IREDELL COUNTY HEALTH DEPARTMENT

IMPROVEMENT PERMIT / AUTHORIZATION TO CONSTRUCT / OPERATION PERMIT / EXISTING SYSTEM INSPECTION

PERMIT# 122554 PIN# ~~4639-64-0340.050~~ 4639642310 DATE 3/22/07

SUBDIVISION Northington Woods BLOCK / SECTION _____ LOT 30 LOT AREA 1.35± Acre SITE CLASS. PS DESIGN FLOW 480 L.T.A.R. .5

INITIAL SITE SKETCH

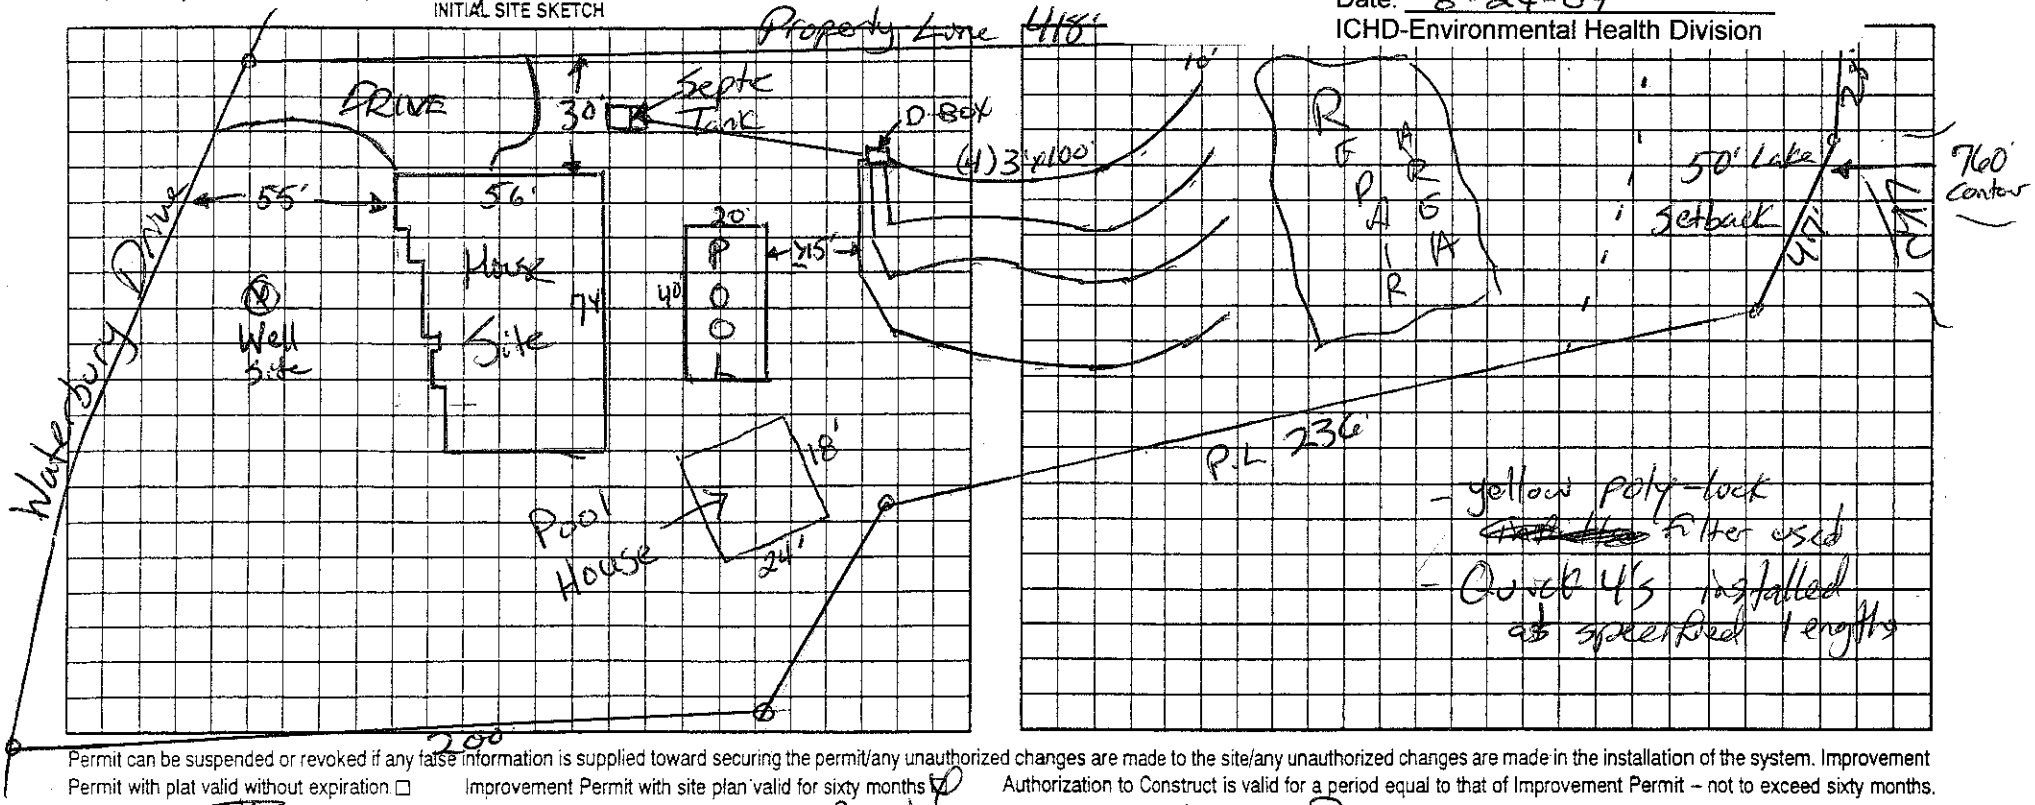
Comments: The proposed / ~~existing~~ Pool addition does not appear to impact the existing septic system.

**NOTE: Keep pool at least 15' from septic & 10' from supply line Judy Melville R.S.

AS BUILT SKETCH

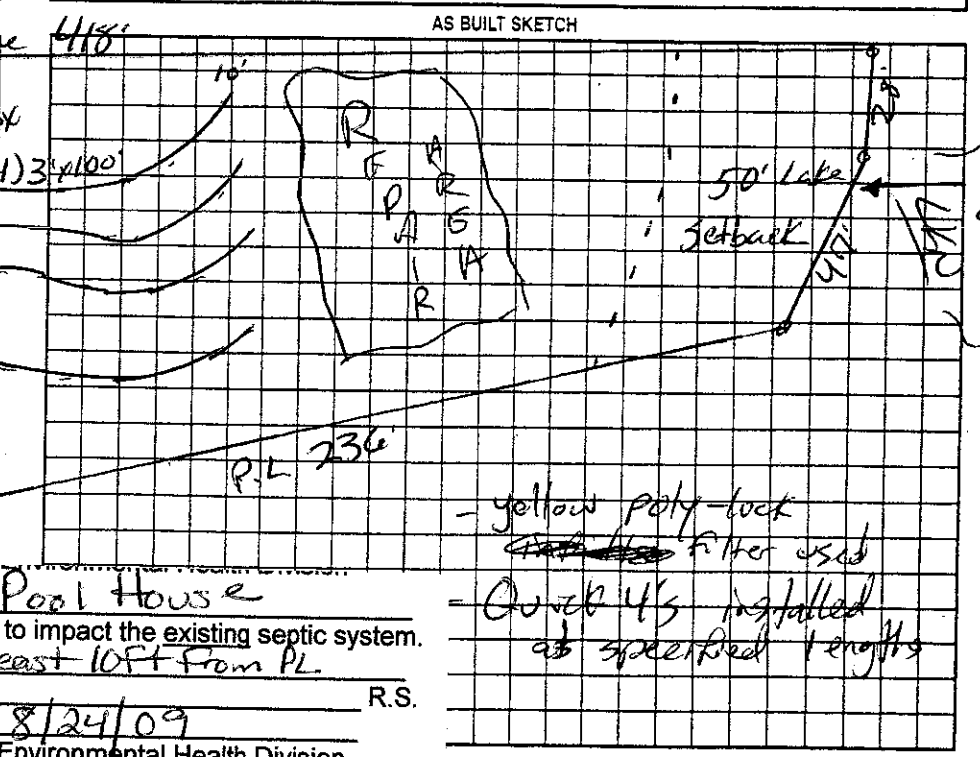
The proposed / existing Pool House addition does not appear to impact the existing septic system.

**NOTE: Stay at least 10ft from PL
